Matters arising from DIO Hearing Statement on RAF Halton

1.1. Crest Strategic Projects ('CSP', representor number 27869) has submitted representations that AVDC had not adequately justified the allocation of RAF Halton in its evidence. The DIO has, as a Hearing Statement to Matter 15.r (Session 21), now finally submitted technical evidence for the proposed RAF Halton allocation D-HAL003 (their representor number 29946). However, as this paper sets out, our concerns over the soundness of the allocation have still not been adequately addressed.

“Building morphology within the site and its immediate context”, p.37

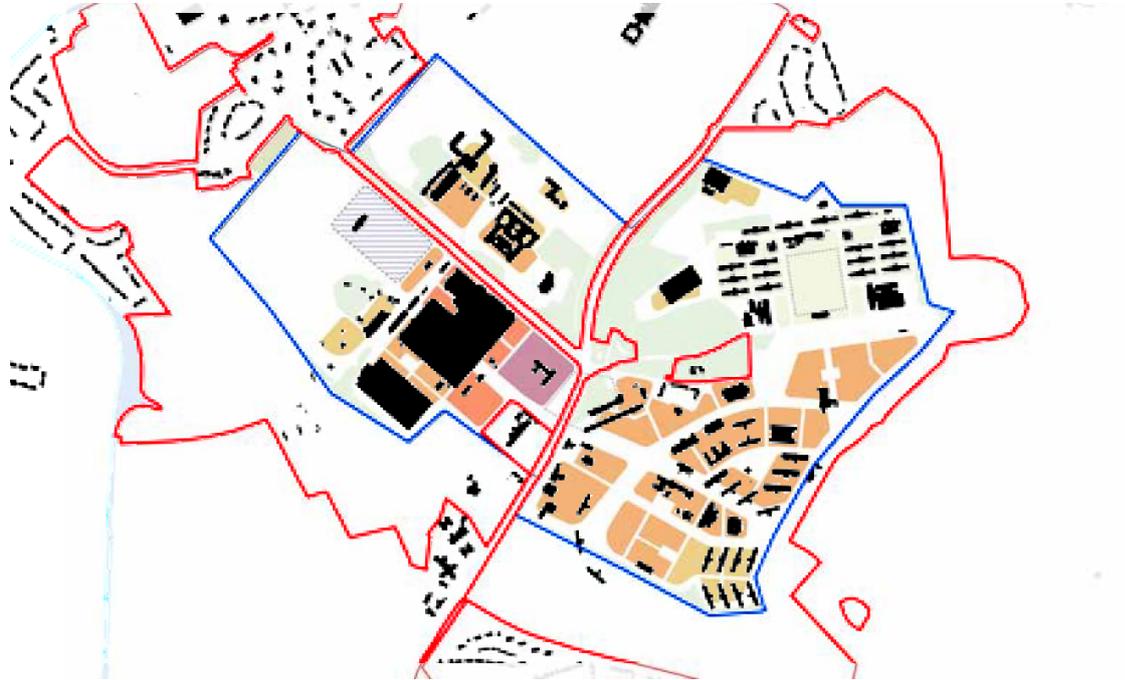
- Page 3 of the JLL Position Statement states that development will be concentrated on already built-up areas, yet the PRP masterplan (p.125) shows residential blocks in what are currently **substantial, open grassed areas**. This is particularly true in the south-east of the site, which is the closest point to the AONB and the SAM (Long Barrow) and classified as *'Area 7.1: RAF Open Lands'* in the Vision Document. A key characteristic in its openness is a series of buildings set within landscape, providing a setting to the listed blocks to the north. Whilst the Vision Document on pages 129-131 details the existing footprint, volumes, conversions and new build figures and surmises a reduction in overall footprint and volume, the new build will not exclusively be on the footprint of existing buildings. As such an impact on openness can be expected (compare pages 37 and 126 of the Vision document, see our Appendix 1).
